**UNION
ELECTRIC**

ULNRC-03342

DOCKET NUMBER 50-483
CALLAWAY PLANT
RESPONSE TO REQUEST FOR ADDITIONAL INFORMATION
CONCERNING THE REVISION TO TECHNICAL SPECIFICATION
3/4.8.1, A.C. SOURCES

Response to Request for Additional Information

Figure 1
Typical Full-Load Rejection Test
(Page 1 of 1)

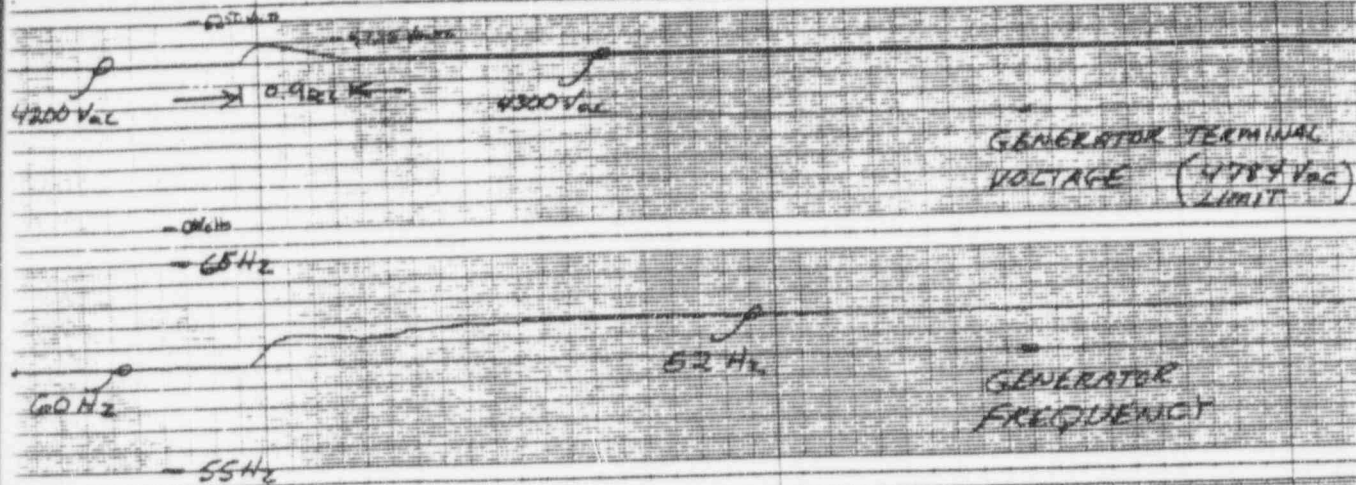
Provide additional justification for removal of Surveillance Requirement 4.8.1.1.2g.2 [4.8.1.1.2f.2], single-load rejection test, from Technical Specifications.

- A. The single-load rejection test is enveloped by the full load rejection test since the proposed change revises the frequency criteria to 60 ± 5.4 Hertz which is the current frequency for the single largest load rejection test. Figure 1 provides a strip chart recording for the Callaway Plant for a typical full-load rejection test. Figure 2 provides a recording for Wolf Creek Generating Station (WCGS) of a typical full-load rejection test.
